Job: 32701
 PORTLAND - BAXTER CSO

Spec Section No: 534
 Submittal No: 30
 Revision No: 1
 Sent Date: 4/29/2013

Spec Section Title: Precast structural concrete
 Submittal Title: 534.80 - Precast concrete building

Plan View

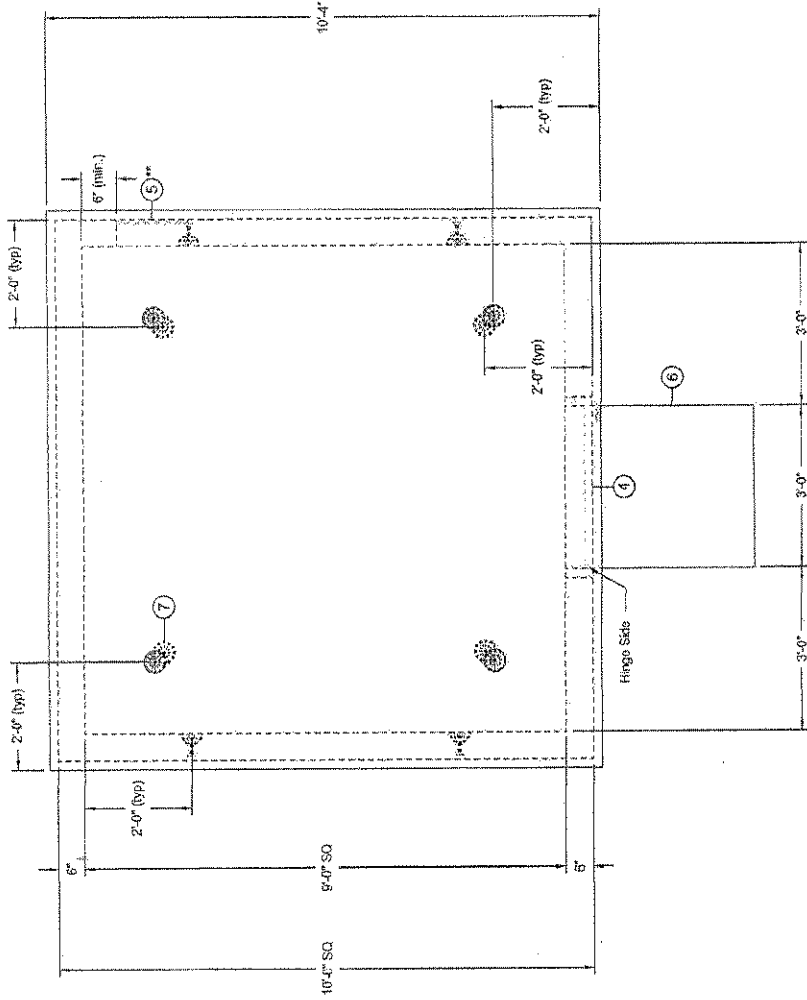
1. Coordinate vent opening with manufacturer.
2. Exterior surface shall be coordinated with City representative.
3. Finish floor elevation to be set at elevation 14.00.
